State of New Mexico
Energy, Minerals and Natural Resources

Form C-103
Revised July 18, 2013

San Mateo
Matador request an open hole and casing size change for the Shinnery Oak SWD #3 (30-015-45535).

Well Name: Shinnery Oak SWD #3 30-015-45535

21-1/4" 2M Diverter

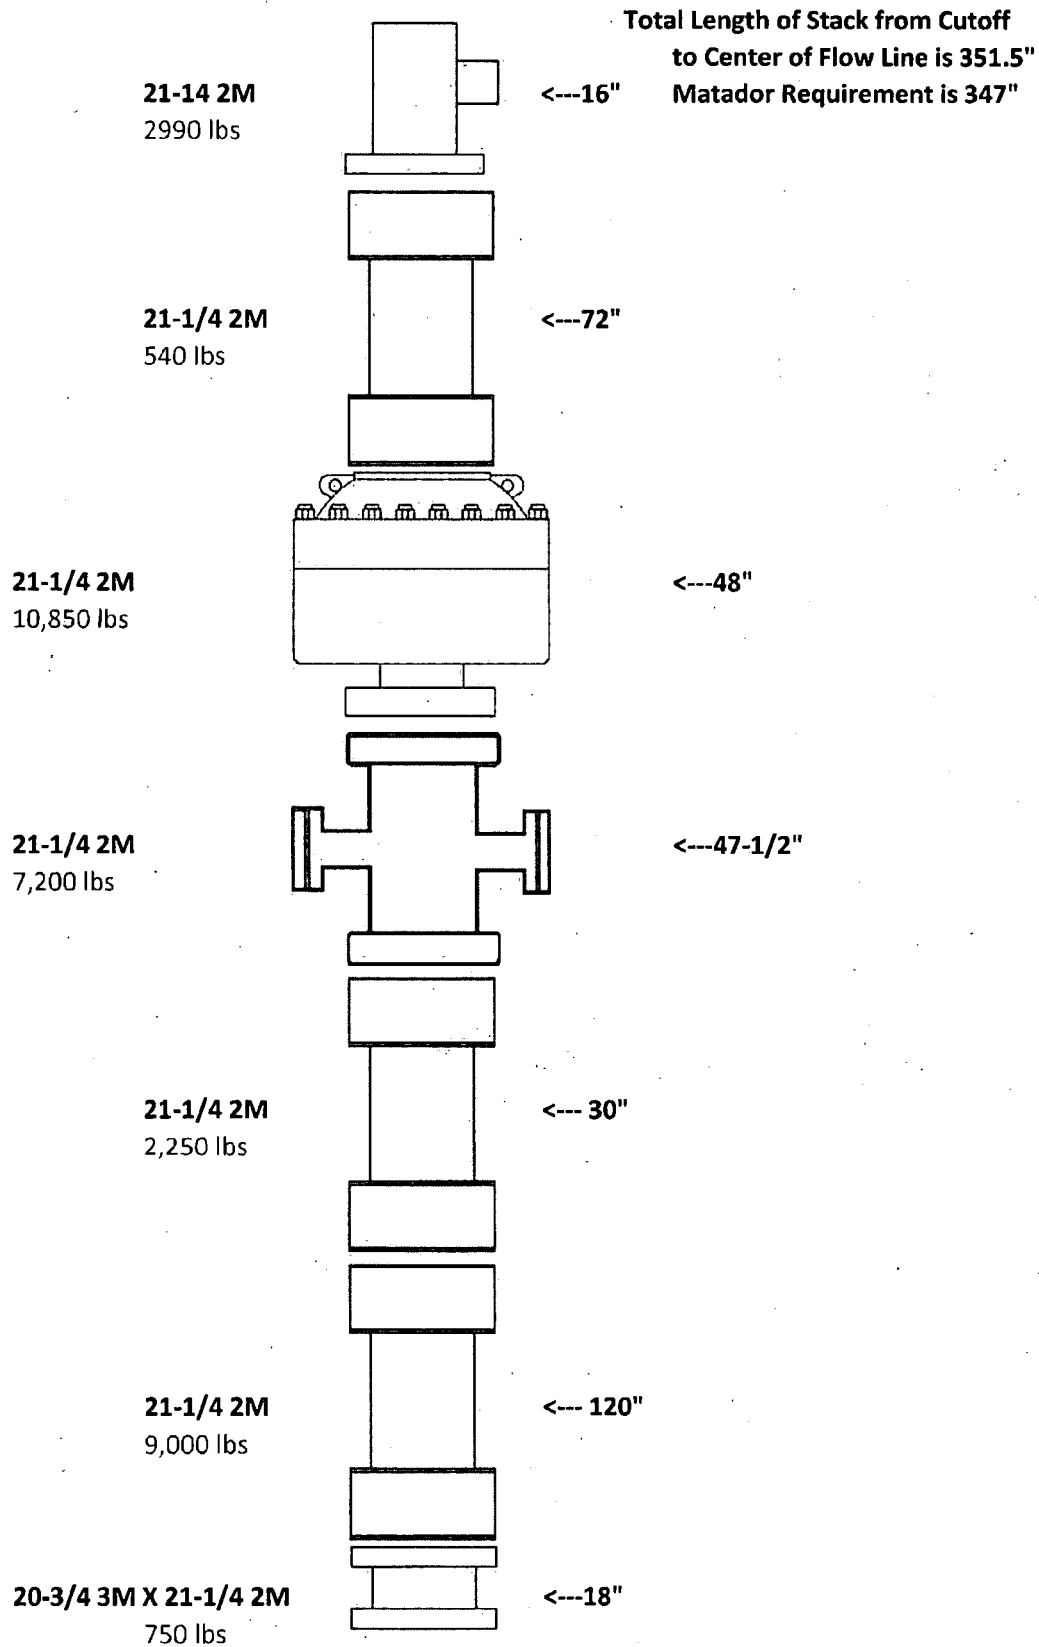
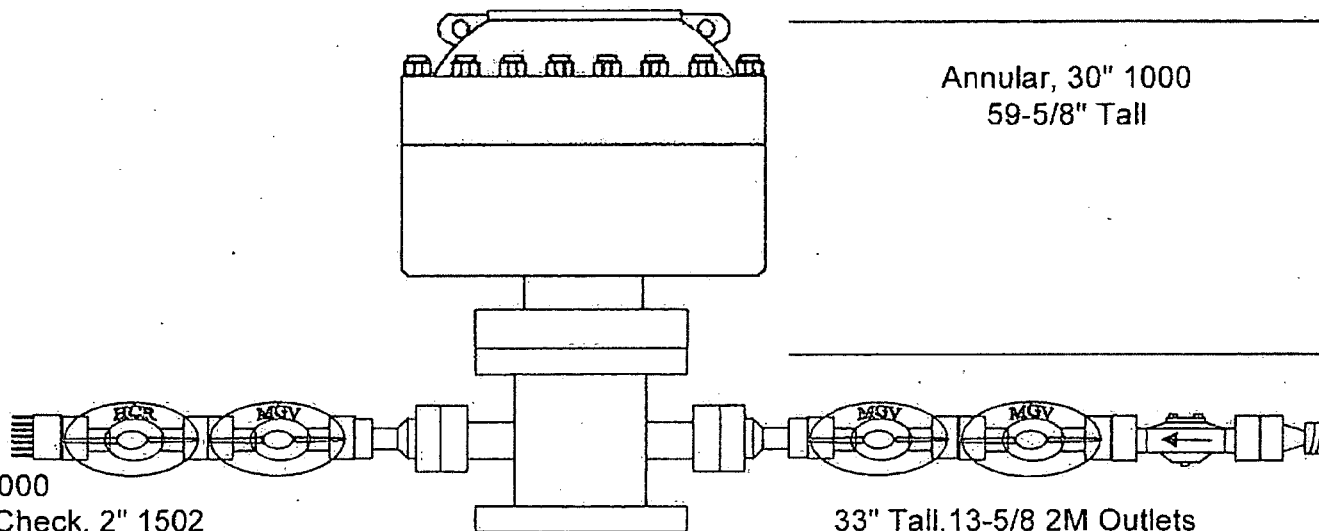
Matador request a change in BOP for Surface and Intermediate 1 casing – both casing sizes larger than standard BOP accommodates:

- Below Surface casing (26"), Working Pressure: 1000 psi, Test Pressure: 500 psi, Type: Annular
- Below Intermediate 1 casing (20"), Working Pressure: 2000 psi, Test Pressure: 1000 psi, Type: Annular

Please see the attached BOP schematics. Standard BOP will be installed after Intermediate 2 casing is set.
